LAKE VALENTINE DAM

NJ 00297

PHASE 1 INSPECTION REPORT
NATIONAL DAM SAFETY PROGRAM

JANUARY 1980

FIGURE 1

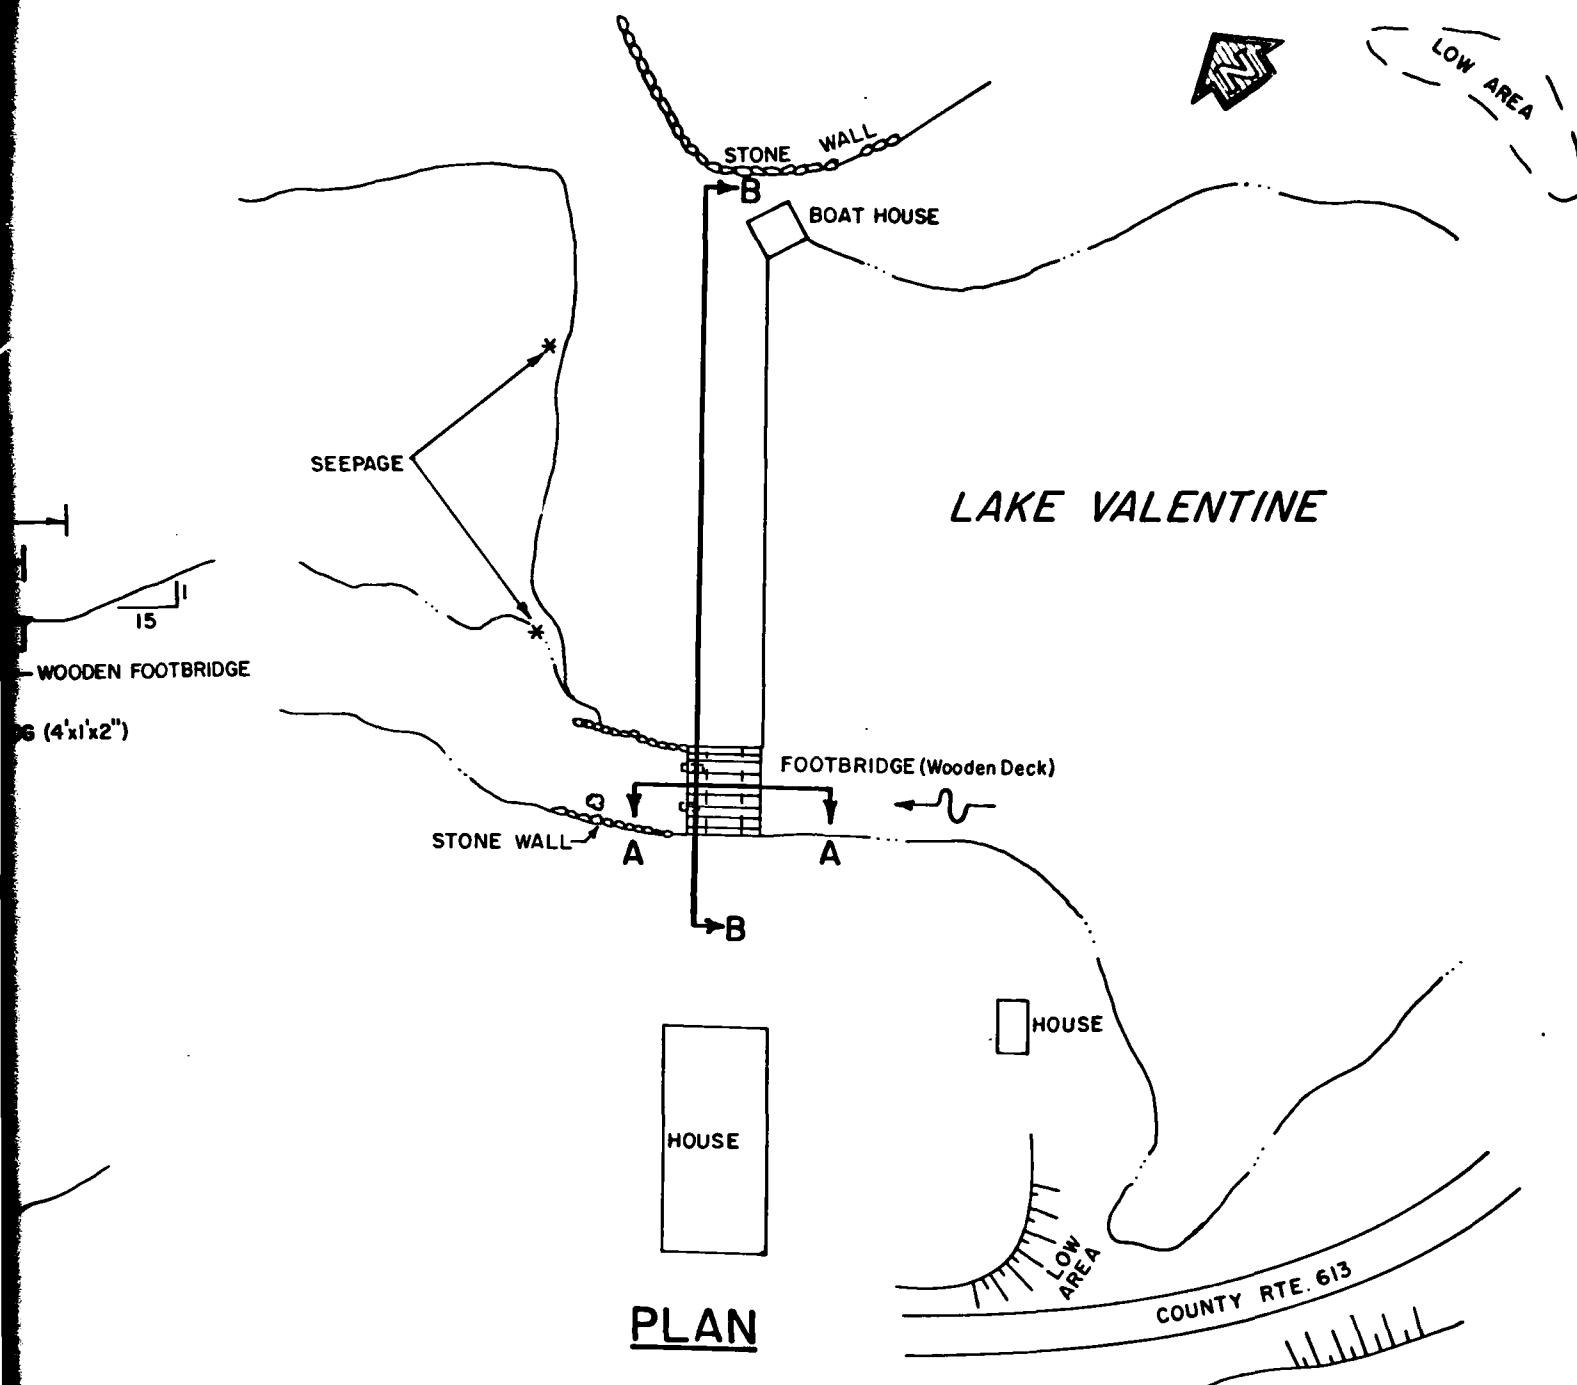
a. Dam. Seepage is discharging at two locations on the downstream toe of the dam. Much of the area immediately downstream of the toe of the dam in the deepest section of the valley is wet and soft. Grass clippings, leaves, and cut brush have been dumped on the downstream slope of the embankment at several locations, including the two locations where seepage is discharging. Fill has been dumped irregularly on the downstream slope of the dam between the center of the valley and the spillway at the southwest abutment; logs, standing trees and boulders have been partially buried under this fill. Trees are growing on the upstream and downstream slopes and crest of the dam. Minor erosion of the upstream slope at the waterline has occurred.

b. Appurtenant Structures. A hole about 4 inches in diameter in the earthen bottom of the spillway approach channel was observed with a small whirlpool (vortex) above the hole. The water flowing into the hole discharges at the base of a broken section of the stone-masonry training wall on the right bank of the spillway discharge channel. Two trees are growing at the base of the stone-masonry training wall on the left bank of the spillway discharge channel. The spillway discharge channel is partially clogged with brush and debris. Some of the mortared stone masonry abutment is eroded and the mortar is broken in several places.

d. Downstream Channel. Major erosion of the left bank of the spillway discharge channel is taking place about 25 feet downstream from the left training wall. Trees overhang the downstream channel.

DAM OVERTOPS AT APPROX. ELEVATION 780.2 FT NGVD
WITH $Q = 83$ CFS

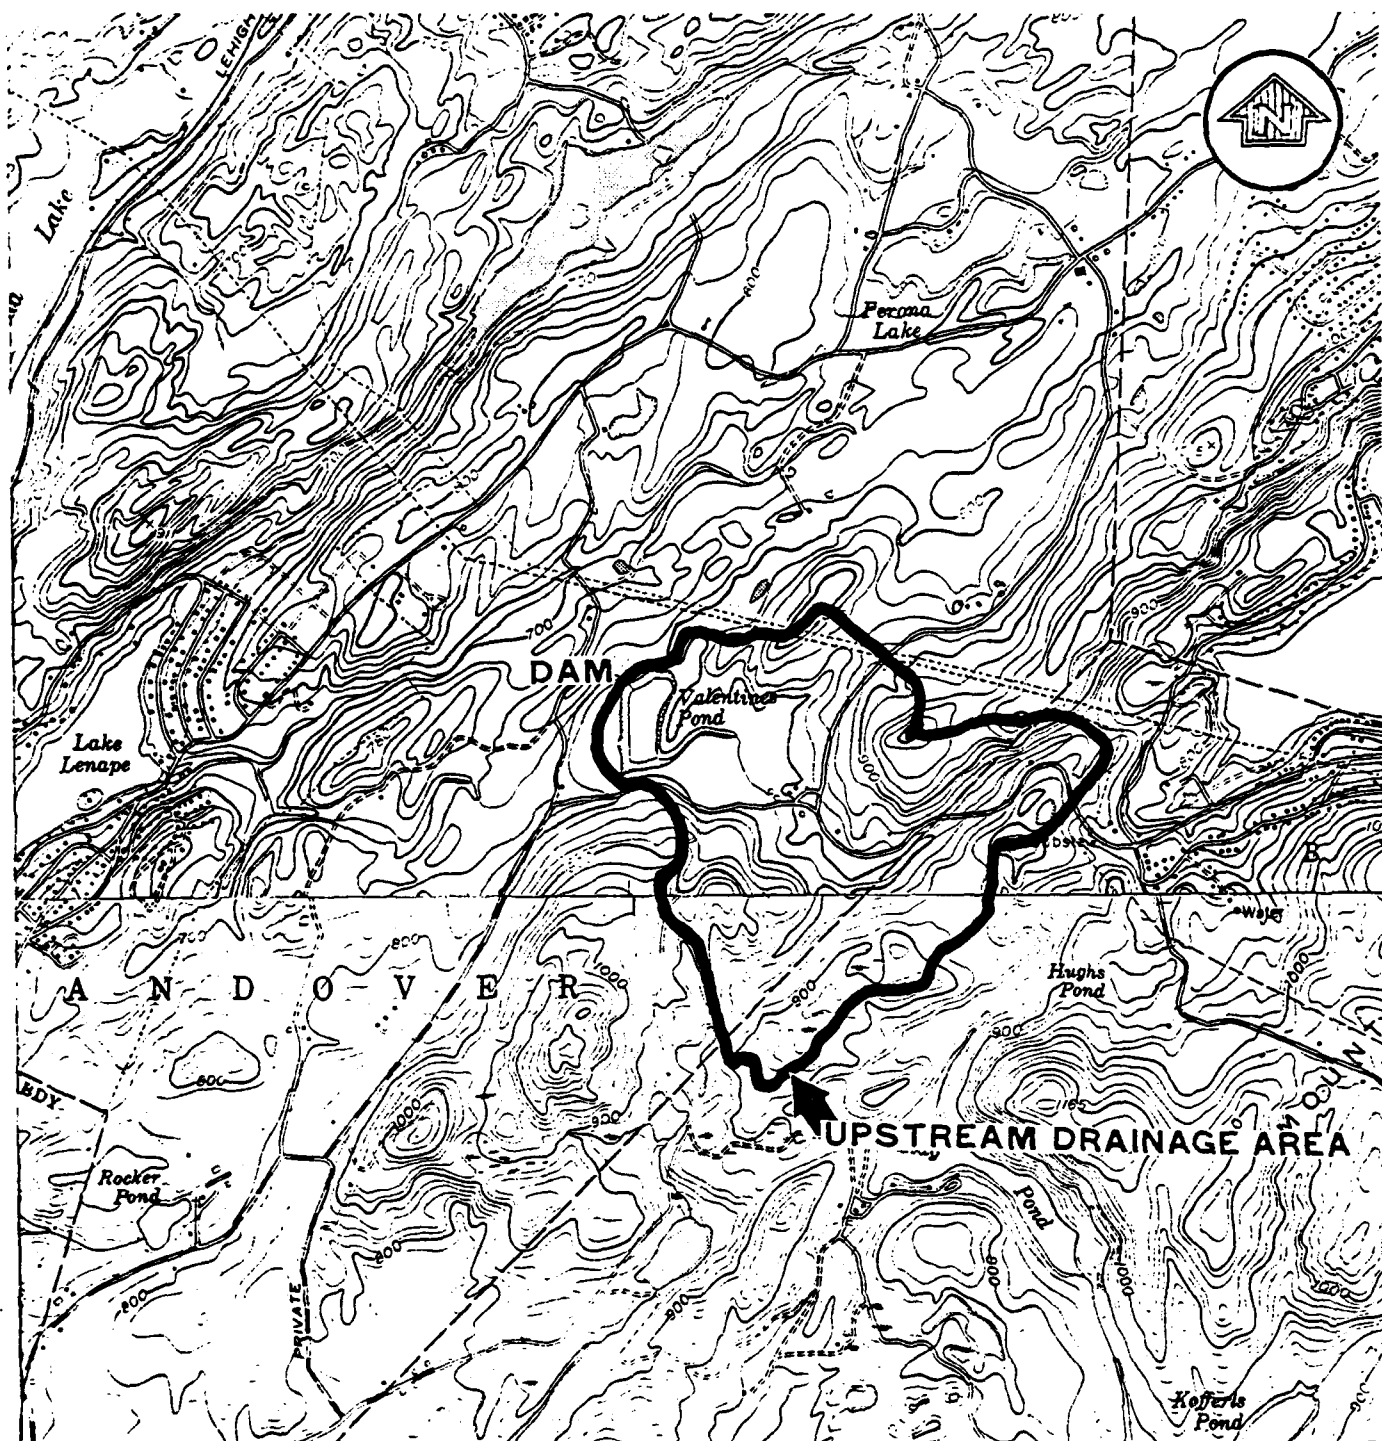
The minimum elevation of the dam allows 1.3 feet of depth above the stoplog before overtopping begins. Under this head, the spillway capacity is 83 cfs, which is less than the required SDF. Under half-PMF condition neither of the natural saddles on the south and north ends of the lake will be overtopped. Flood routing calculations indicate that Lake Valentine Dam will be overtopped for less than 7 hours to a maximum depth of 1.9 feet under half-PMF conditions. It is estimated that the dam can pass only 3 percent of the PMF without overtopping; thus the spillway is considered inadequate.

\therefore SPILLWAY CAN PASS $\sim 3\%$ OF PMF.

(6) Conduct further hydrologic and hydraulic analysis of the watershed reservoir and spillway, to determine the need for and type of mitigating measures to prevent overtopping.
